Danielle Gray, Principal Consultant
Gray Planning
224 Warwick Street
West Hobart TAS 7000

9 December 2025

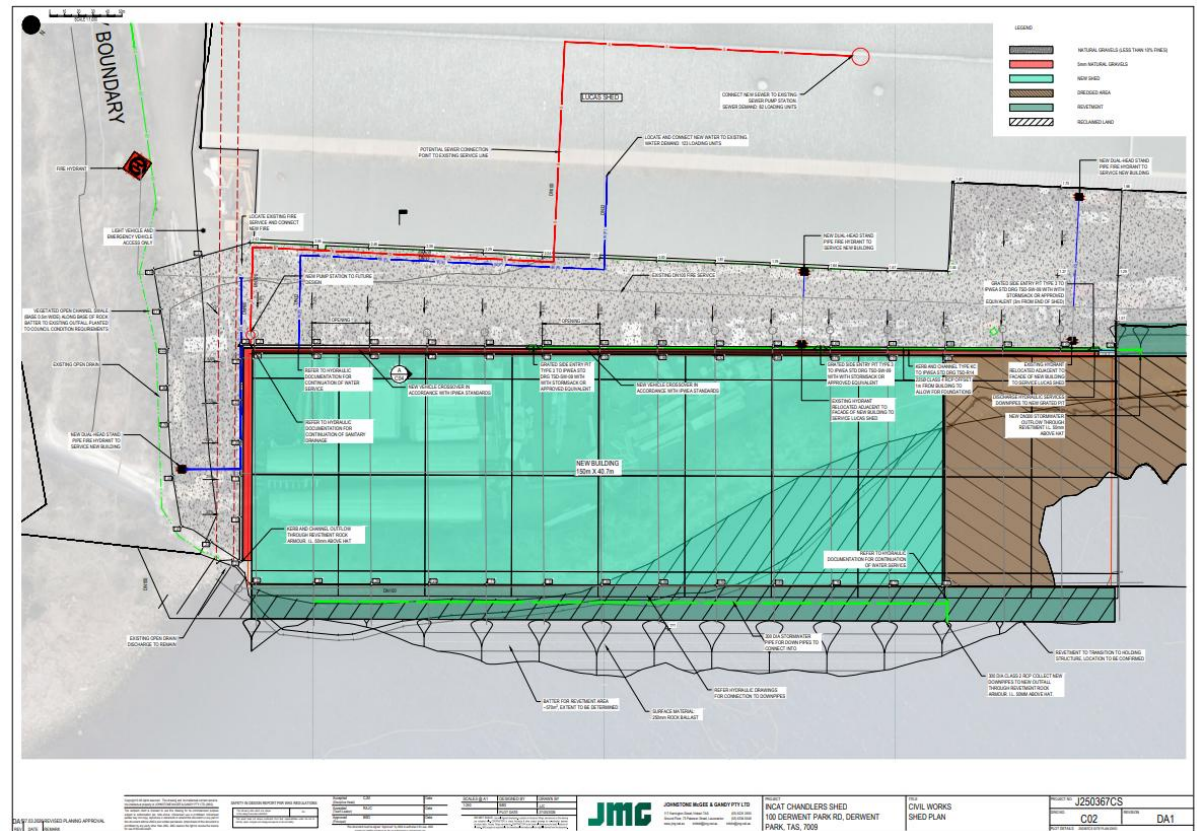
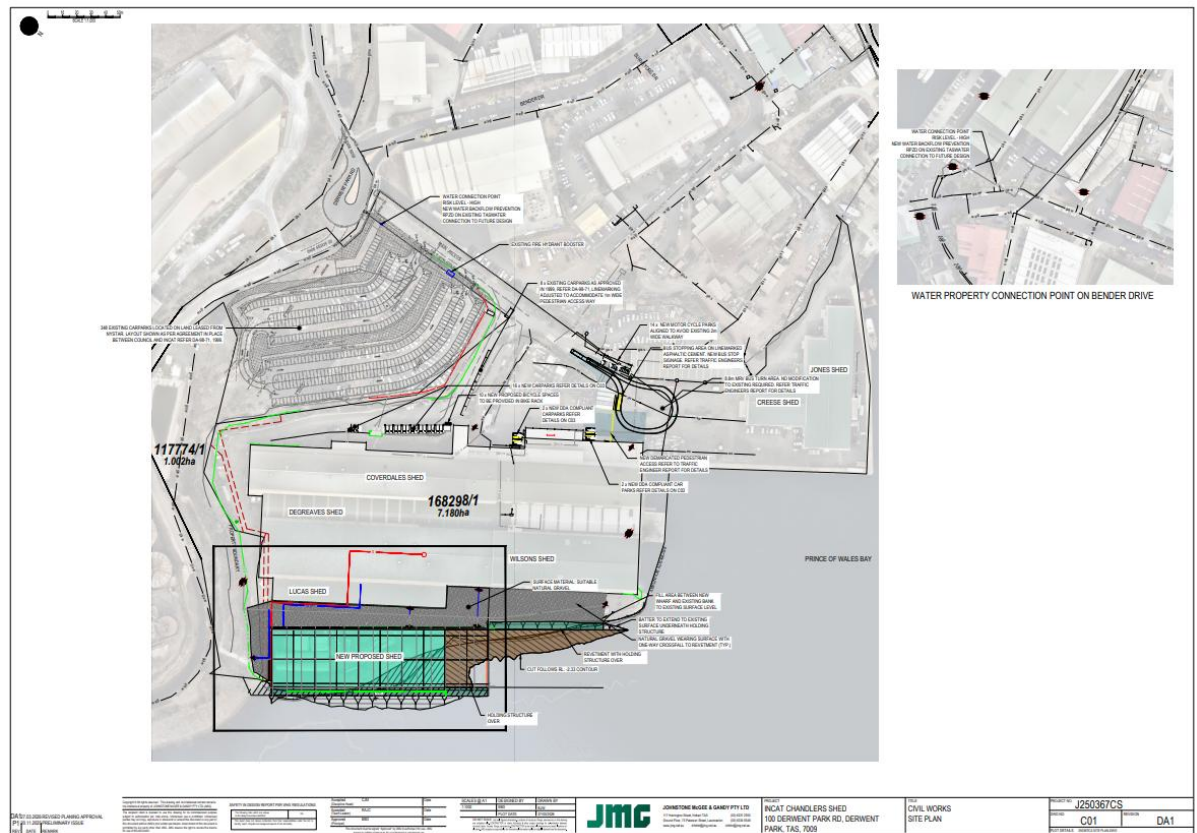
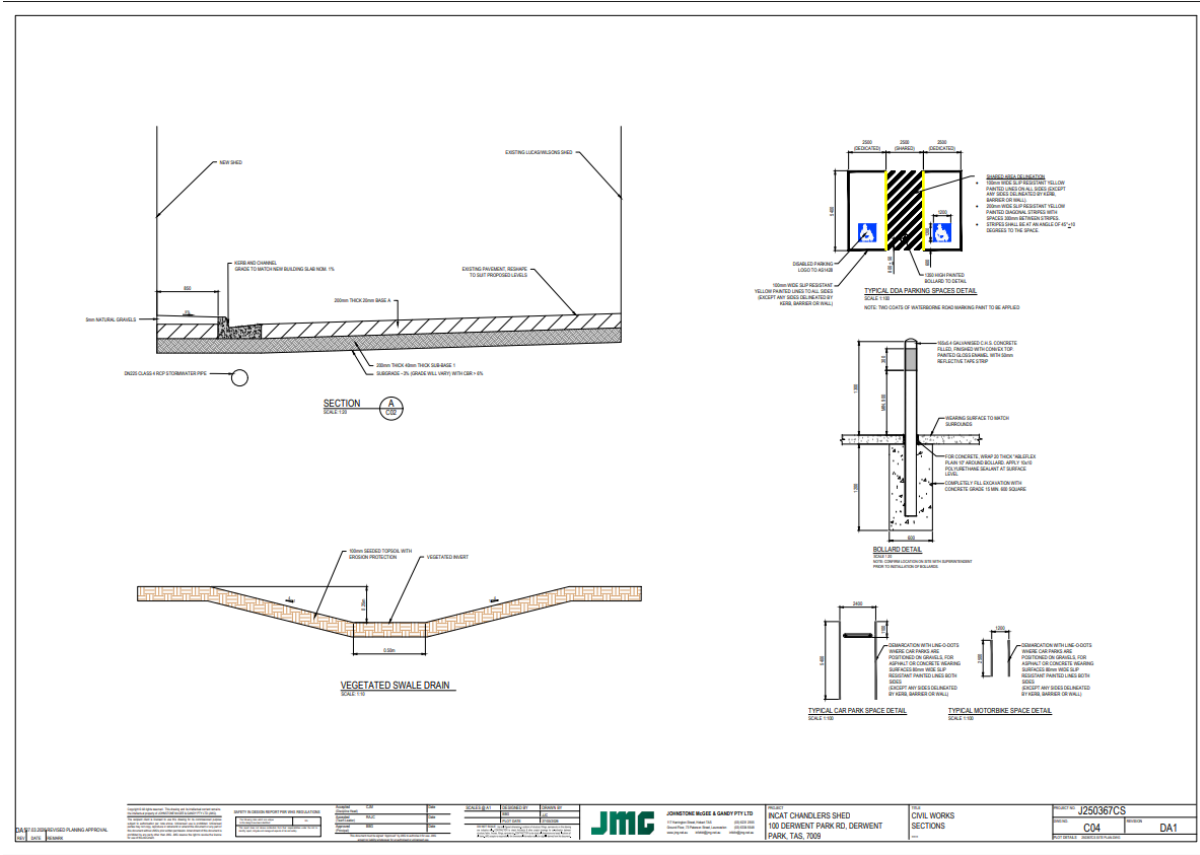
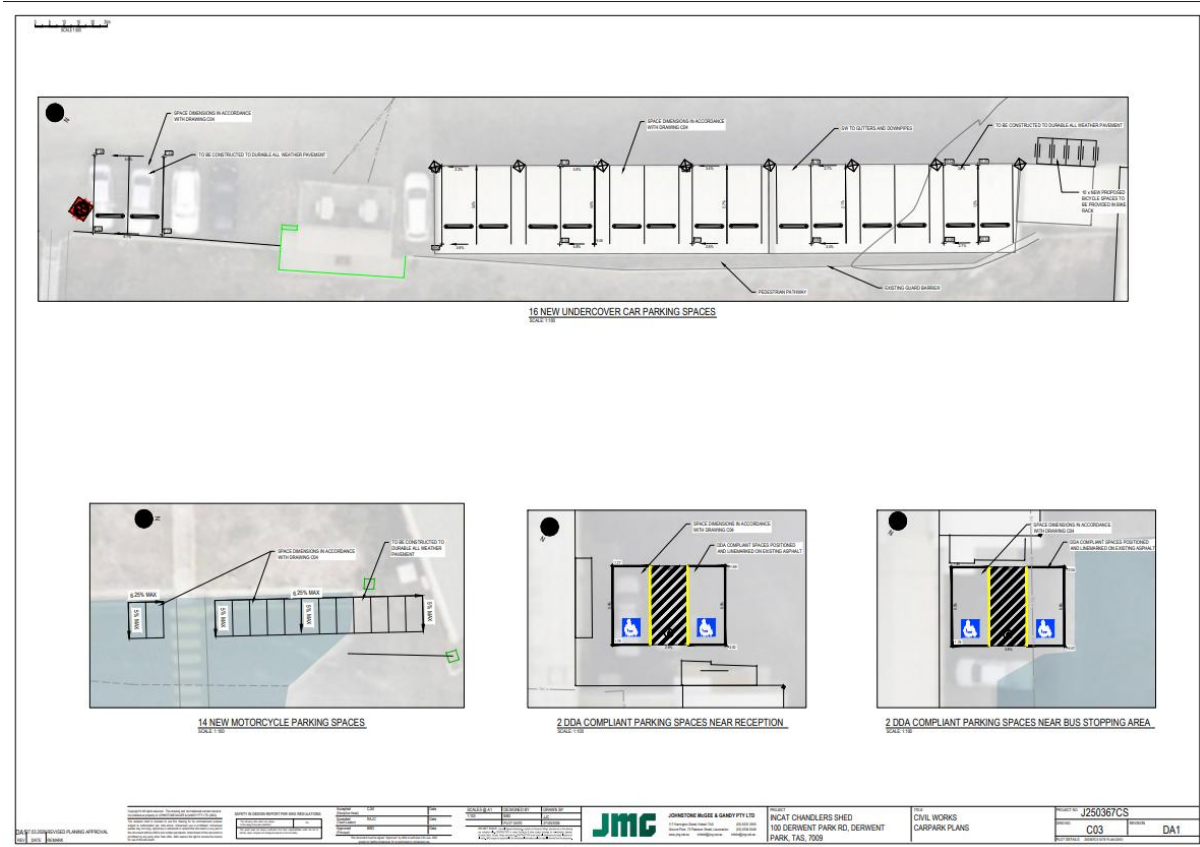
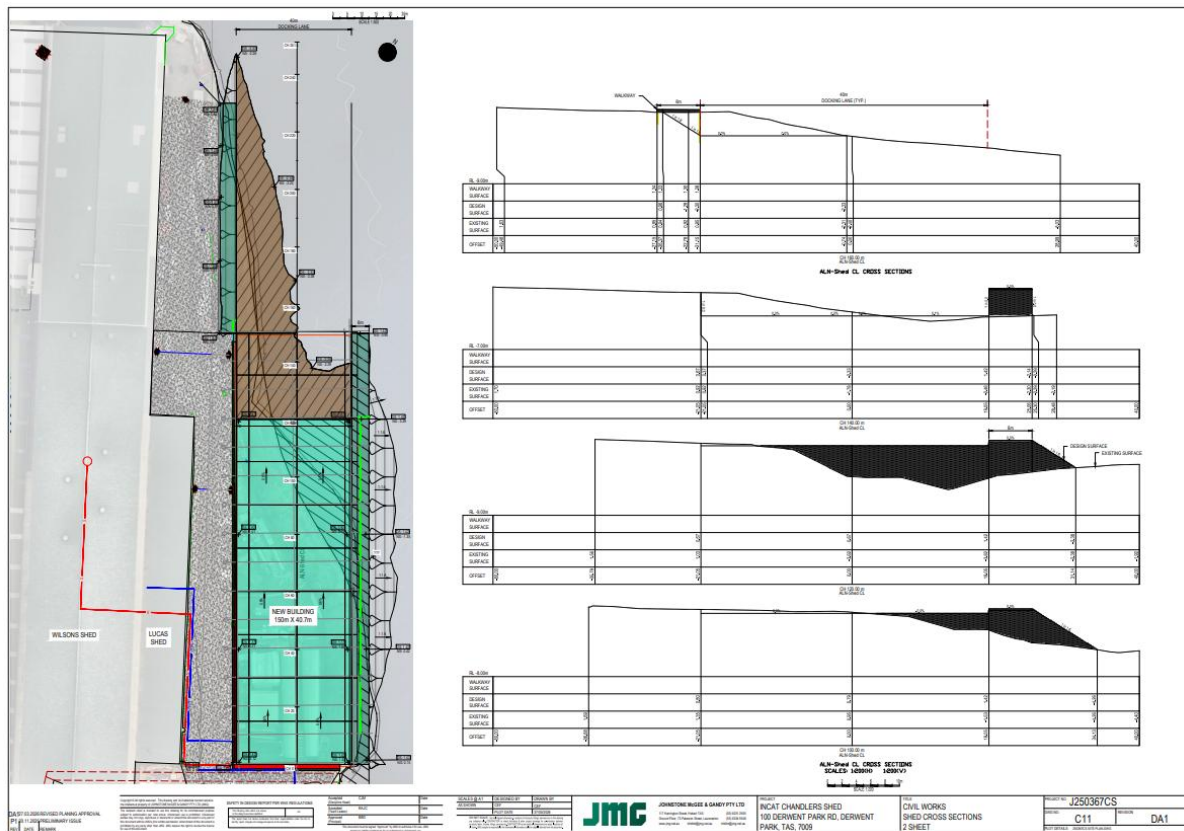
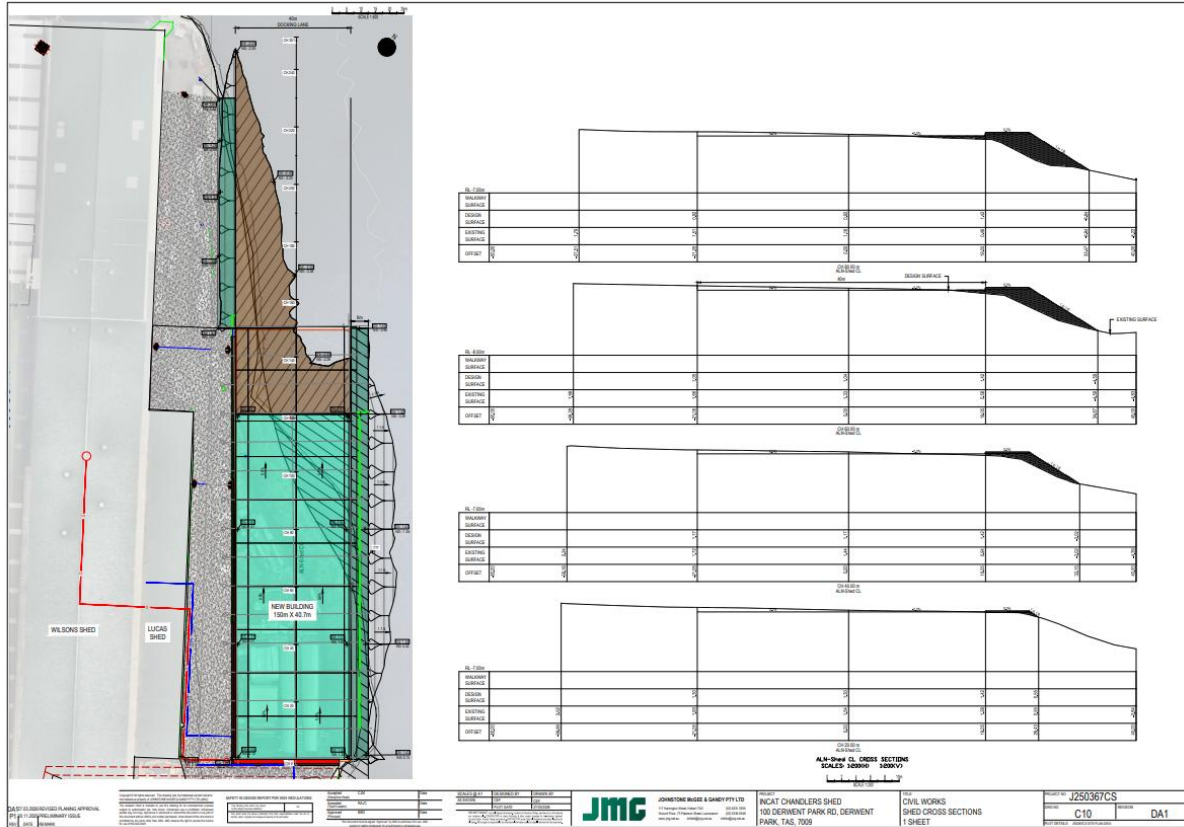
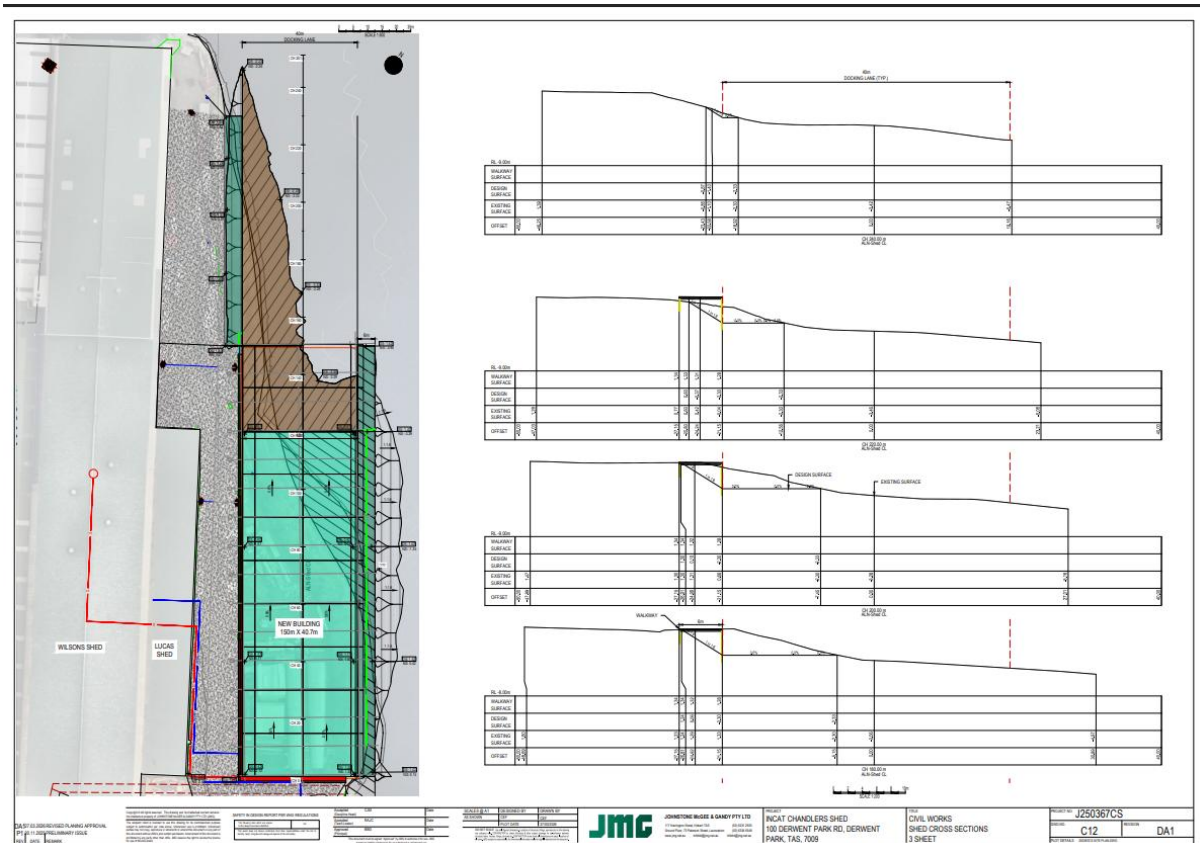
The updated JMG plans dated 27 March 2026 (car parking, fill and servicing) for the proposed Boat Building and fill/reclamation proposal have been provided by JMG and comprise the following plans in response to the Council RFI and also referred to Crown:
